DEPARTMENT OF PLANNING AND DEVELOPMENT
CITY OF CHICAGO

January 5, 2024

**Re: Minor Change to Residential-Business Planned Development No. 1522, Subarea A
901 N. Halsted St.**

DRAWING
SUBAREA 'A'
SITE PLAN

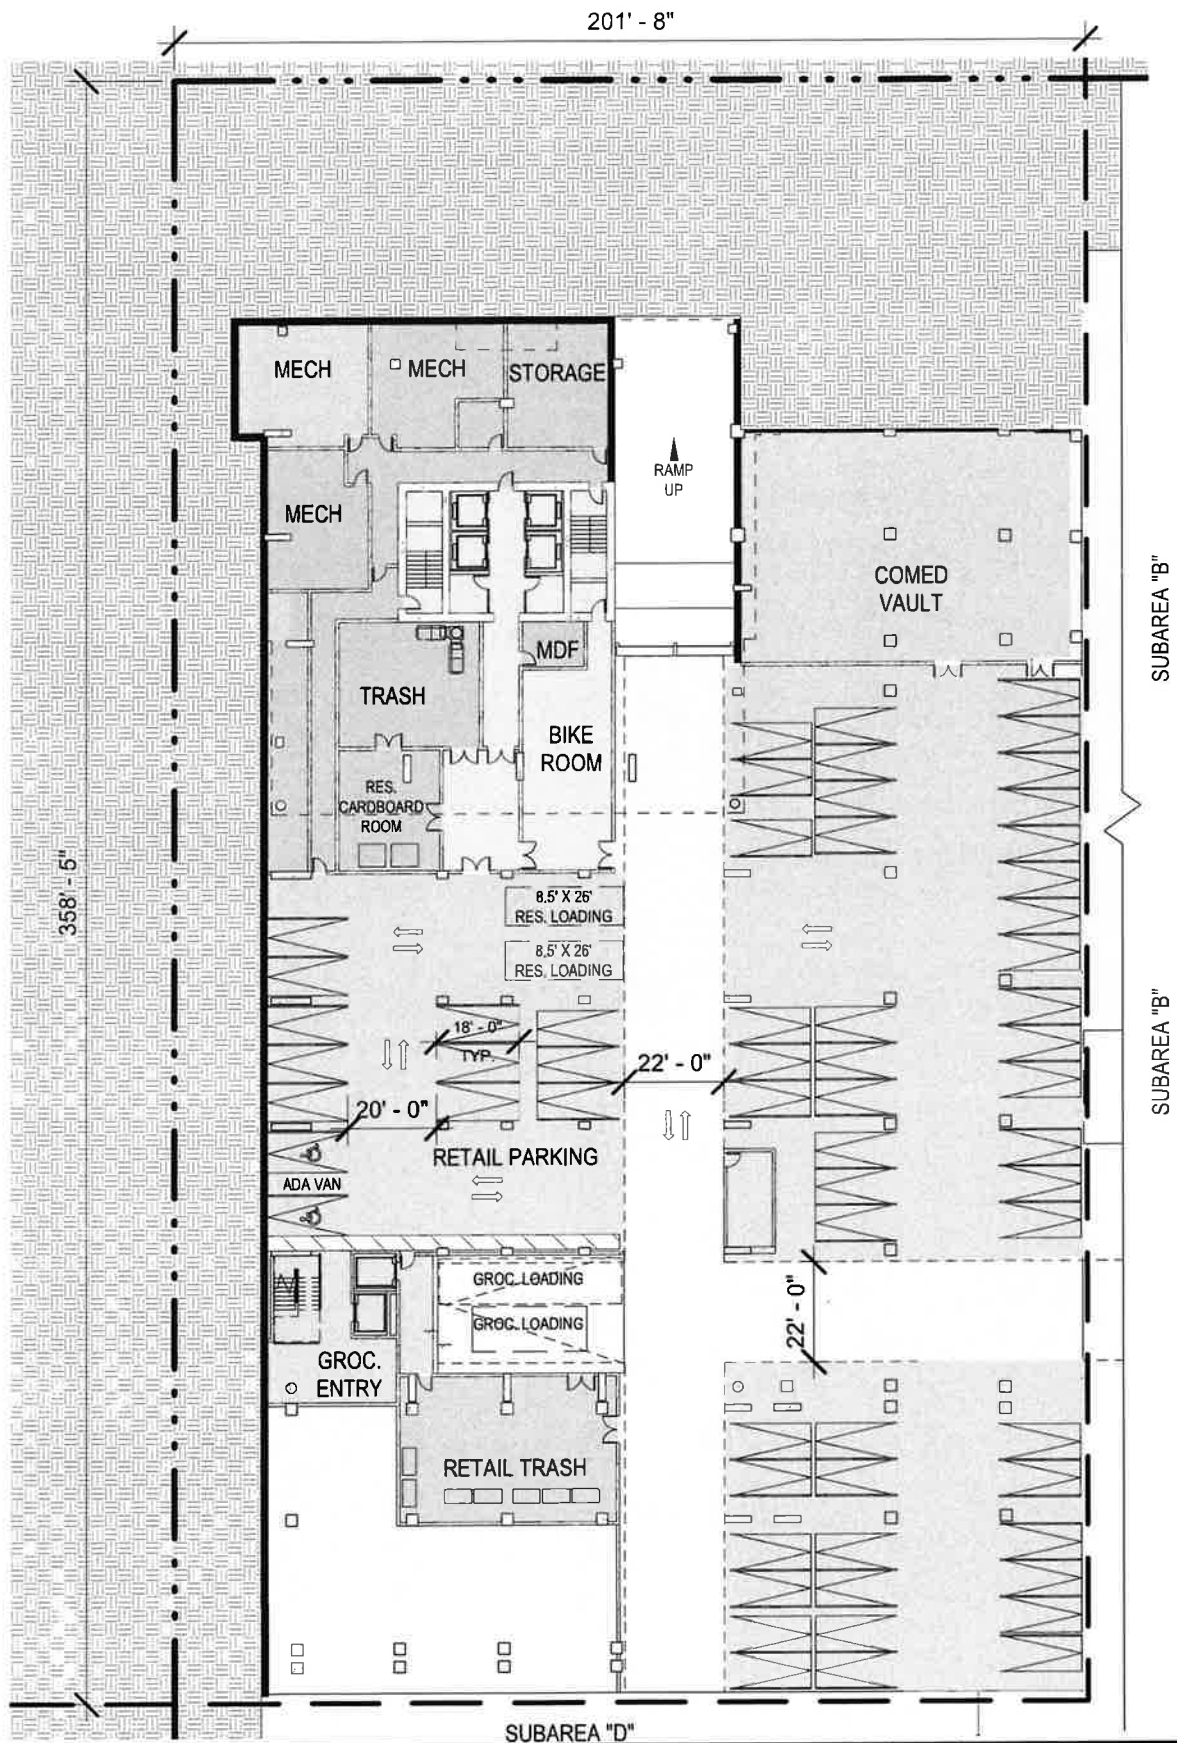
- Shift the southern boundary line of Subarea A south 2'-1" to accommodate a landscape buffer along the southern boundary while future phases are under construction.
- Shift the eastern boundary line of Subarea A east 12'-0" to accommodate MEP infrastructure on the lower levels.
- Increase the building height by 4'-10" (total 501'-10") to accommodate an elevator machine room that was added to top of the building.

COMPARATIVE SUBAREA 'A' SITE PLAN

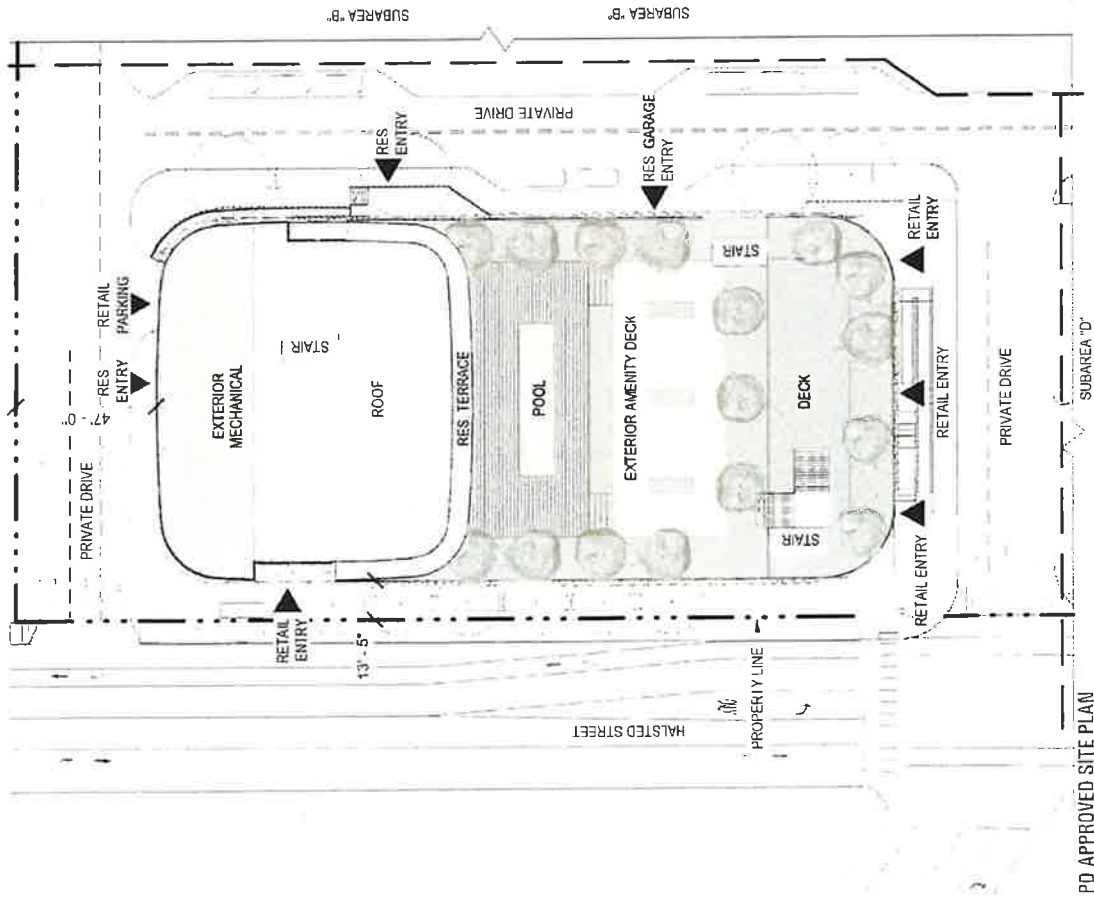
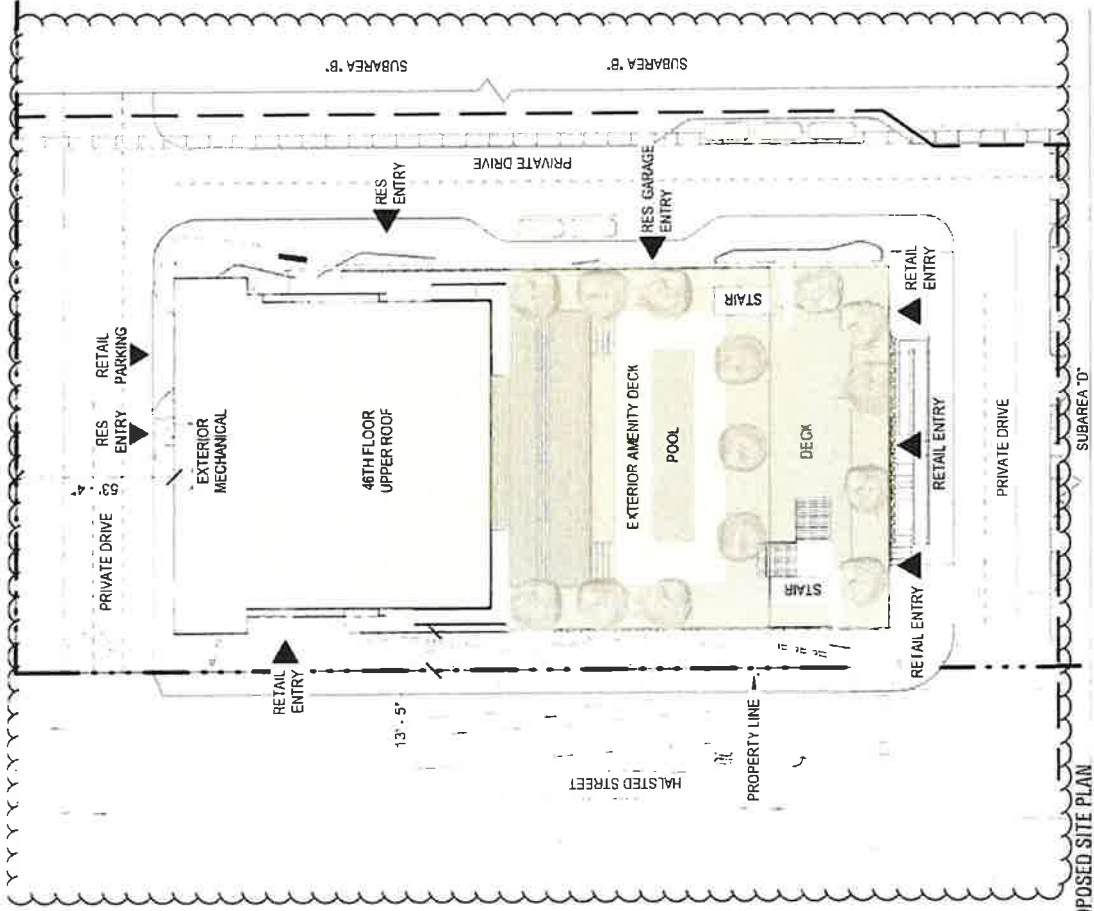
PROPOSED DESIGN REVISIONS - SUBAREA 'A'

COMPARATIVE LOWER LEVEL 2 PLANS
 1" = 40'

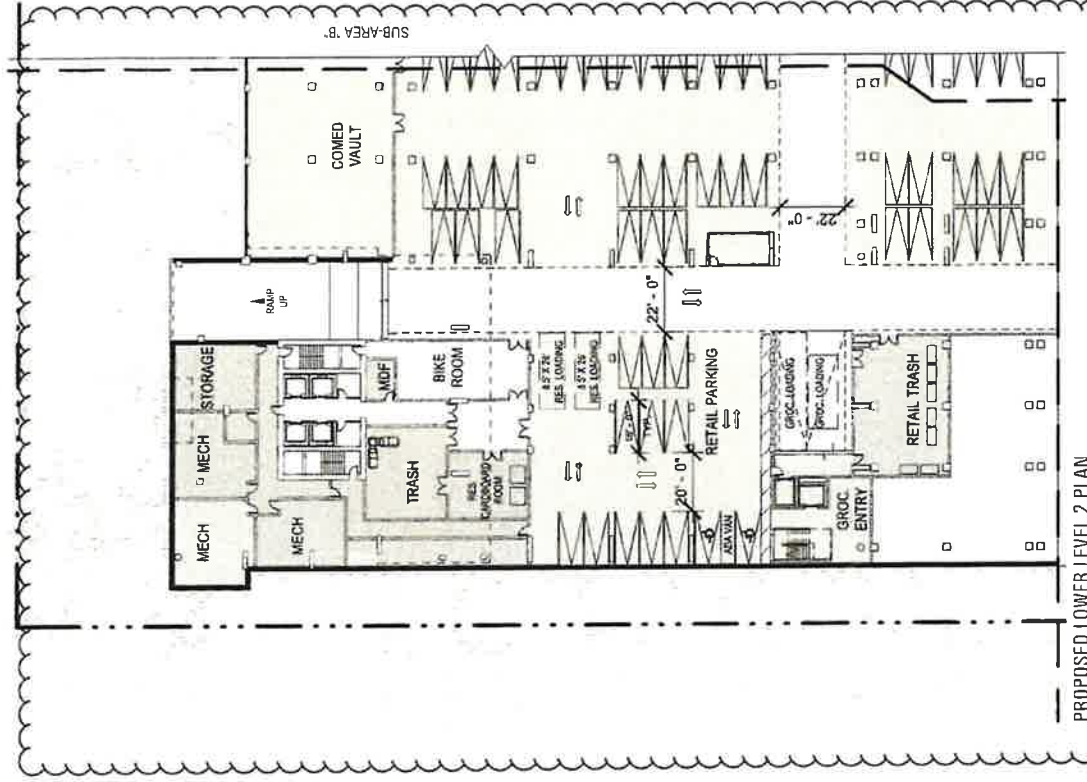
PD APPROVED LOWER LEVEL 2 PLAN SUBAREA 'D'

PROPOSED LOWER LEVEL 2 PLAN

COMPARATIVE LOWER LEVEL 1 PLANS

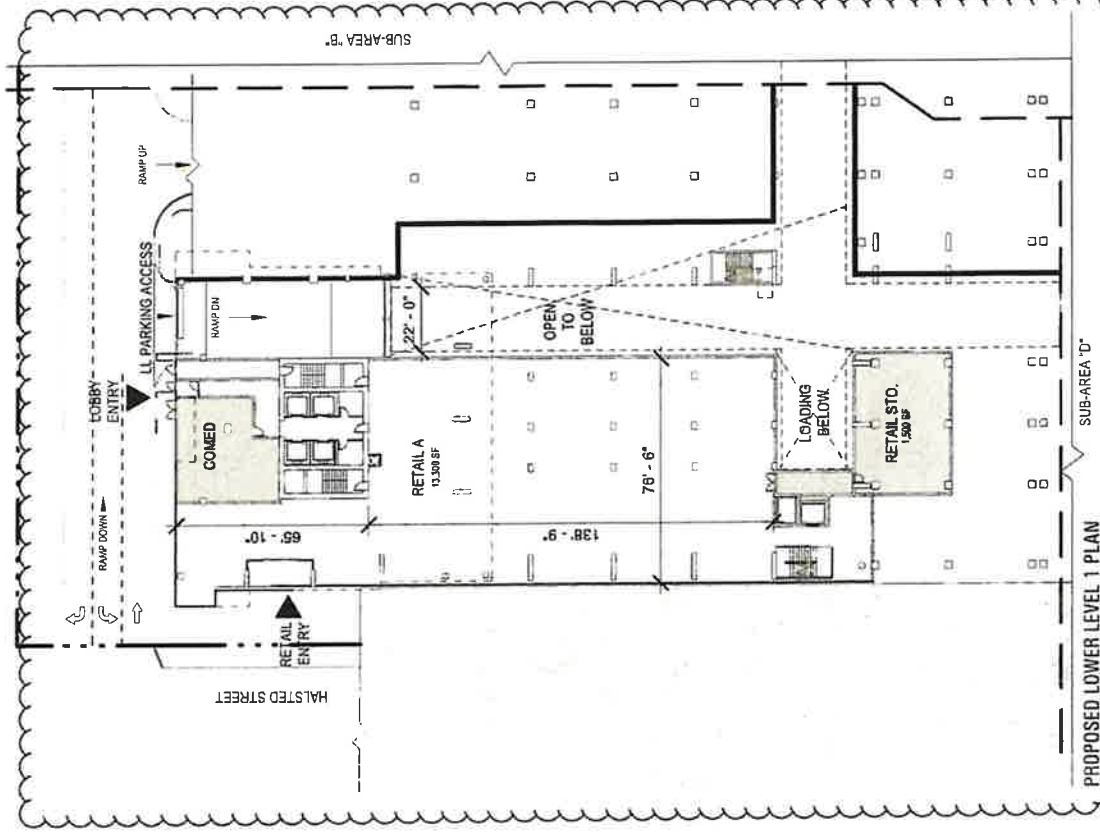
PROPOSED LOWER LEVEL 1 PLAN

COMPARATIVE 1ST FLOOR PLANS

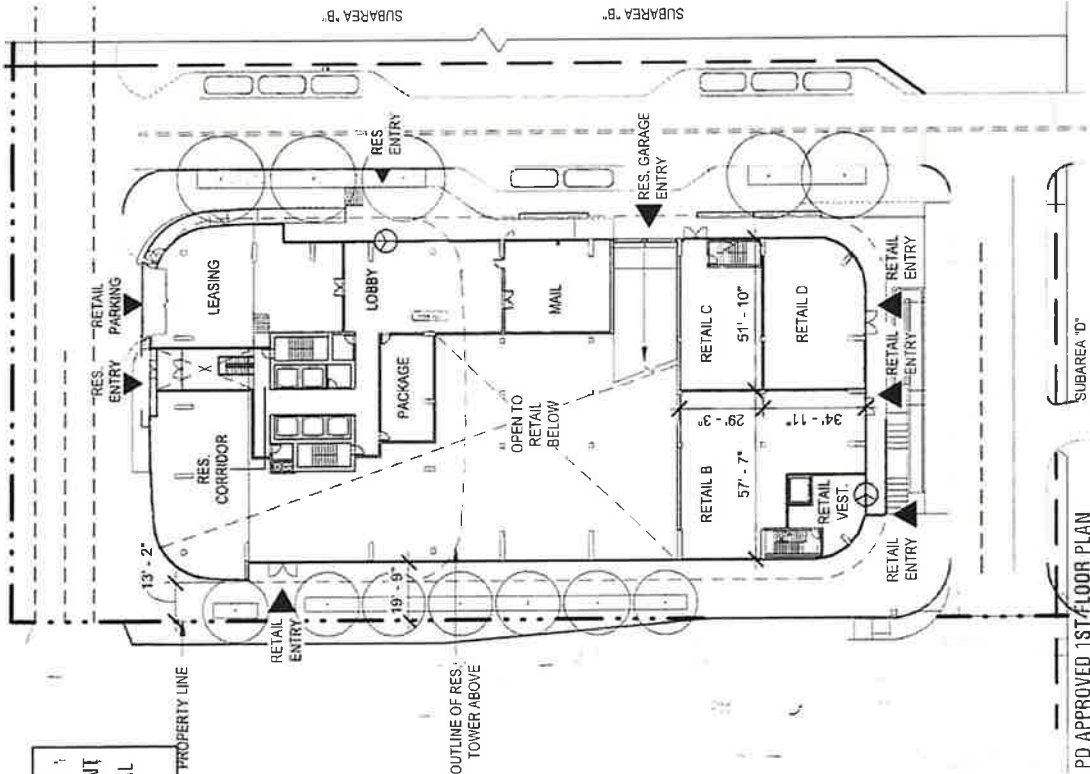
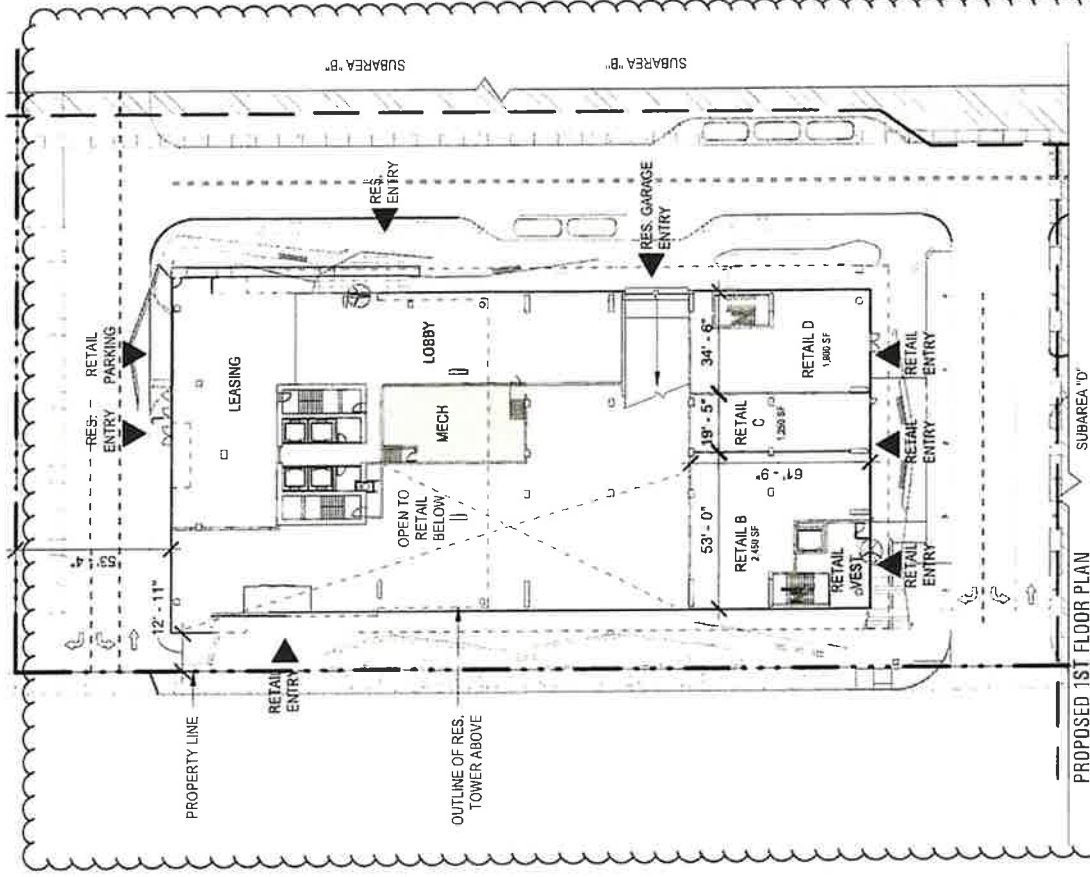
PROPOSED 1ST FLOOR PLAN

COMPARATIVE TYPICAL FLOOR PLAN
 1/16" = 1'-0"

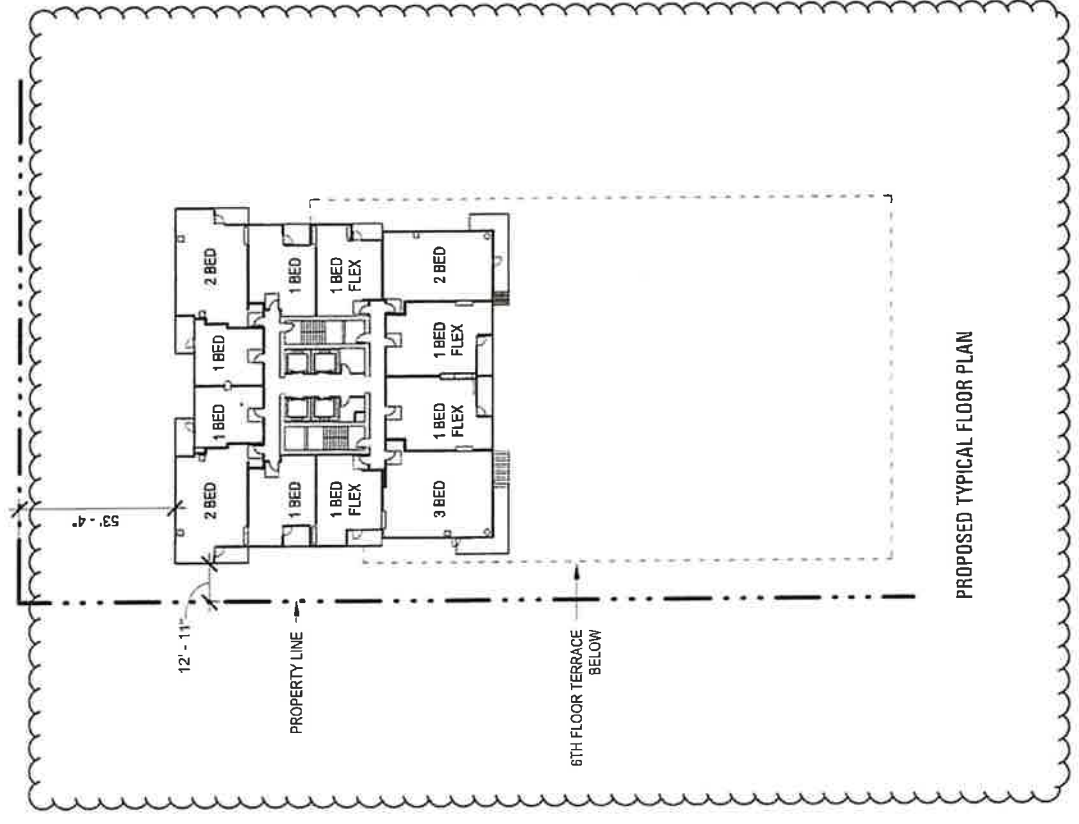
- PROPOSED CHANGES:
- > Typical floor unit mix was revised to include more bedrooms per floor
 - > All units on a typical floor now include a balcony
 - > The setback between the building and the northern property line was increased 6'-0"

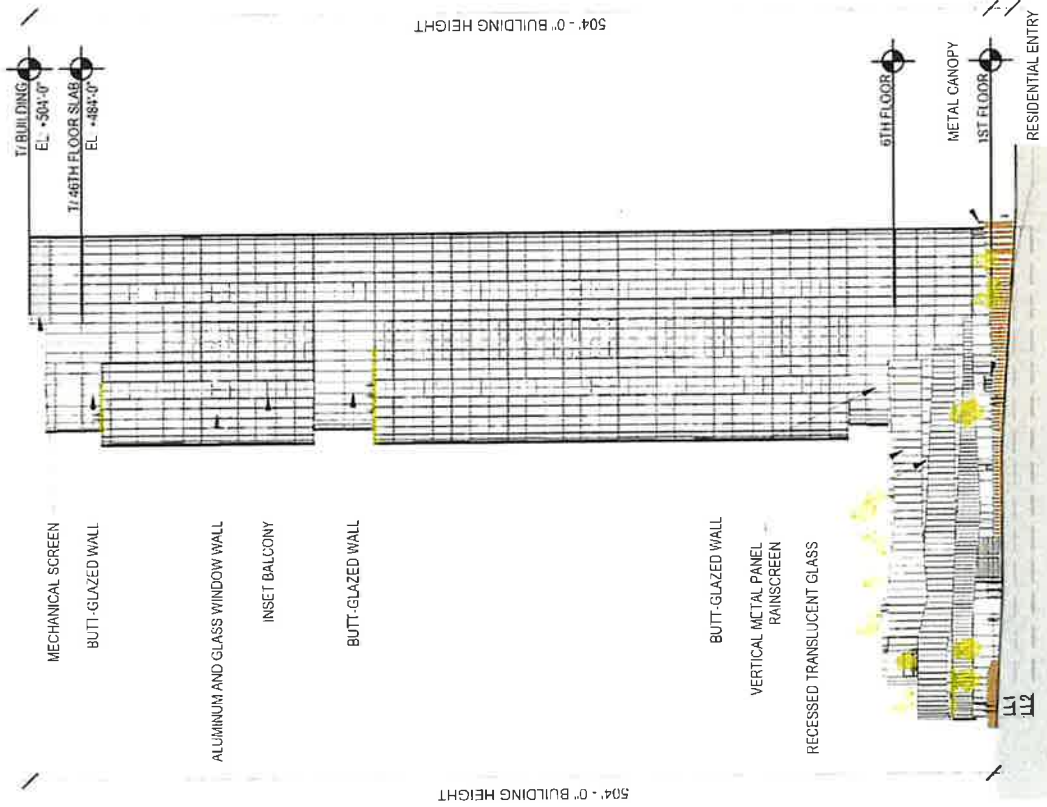
- > Height of building reduced
- > Revised facade on tower uses one captured glass system with (2) glazing and mullion colors
- > Corners of tower are squared off and more dynamic
- > Angular expression in the tower is followed through on top and base
- > Design of tower incorporates angled mullions and angled balcony walls
- > More depth and plane changes introduced to the tower facade

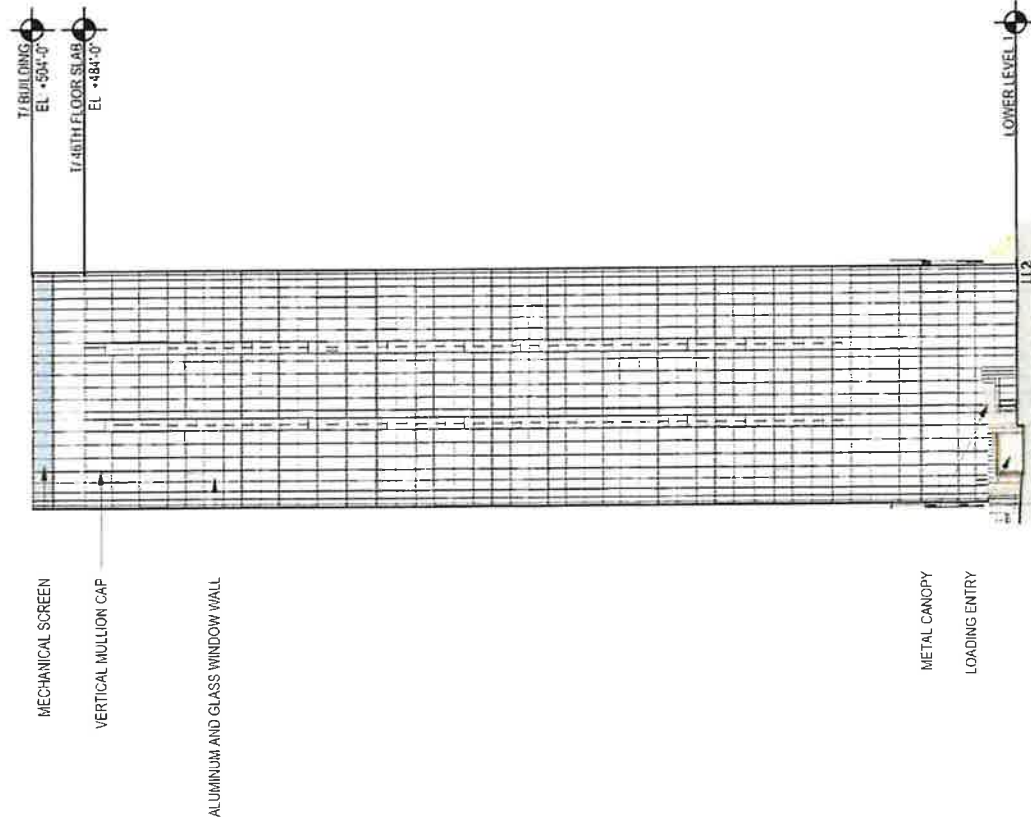
- > Height of building reduced
- > Revised facade on tower uses one captured glass system with (2) glazing and mullion colors
- > Corners of tower are squared off and more dynamic
- > Angular expression in the tower is followed through on top and base
- > Roof top mechanical screen utilizes the same materials and architectural expression as base to create a more expressive and cohesive crown to building
- > Design of tower incorporates angled mullions and angled balcony walls
- > More depth and plane changes introduced to the tower facade
